UNITED STATES PATENT AND TRADEMARK OFFICE

10/798,619

Office Action Summary

DETAILED ACTION

FIG. 2

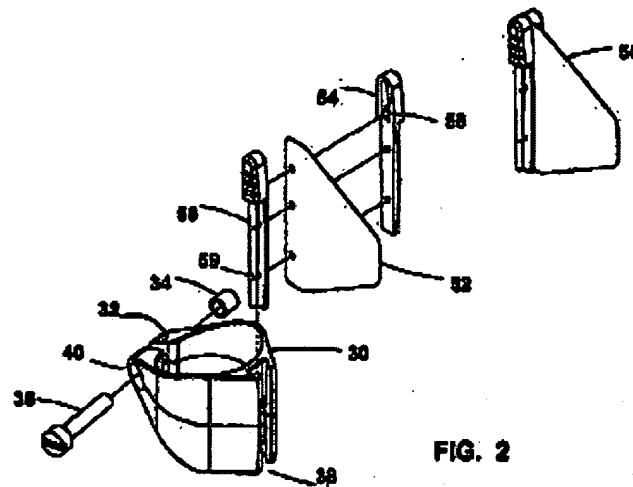
Coleman discloses a vibratory member (52) configured to be vibrated by the spokes of a rotating wheel; and a main body supporting the vibratory member (52) on the vehicle, the main body further comprising an identity plate (54,56); the identity plate (54,56) comprising one or more panels (paragraph 0041, lines 8-9) bearing identification indicia or decorative elements (paragraph 0056), the panels being selectively and releasably attached to the main body (*the panels are attached via reference parts 54,56, which is removable via sliding into portion encompassed by reference part 30 while reference part 38 {main body} stays attached to the vehicle frame, see Figure 2*) such that the identification indicia or decorative elements on the vehicle can be changed by replaced a panel attached to the main body without removing the main body from the vehicle (paragraph 0042, lines 26-29); the vibratory member (52) snaps into a socket (30) on the main body (38) (via grooves of flapper mount assembly 50 and raises within the channel of the mounting clamp enclosure 38); the socket (30) having an inner (the inner portion of reference part 30) and outer rings (the outer portion of reference part 30) of the socket; the vibratory member is configured to snap into

the socket at any of a variety of angles with respect to the main body so as to accommodate differently sized bicycles (paragraph 0055).

With respect to the zip tie fastening element, Coleman recites that a variety of other fastening means may be used such as ties, snaps, buckles as well as screws to secure the flapper mount assembly in the enclosure 38 (paragraph 0042, lines 29-32). Coleman further shows apertures in the flapper mount assembly to be used with the above recited fasteners (Figures 2 and 5A).
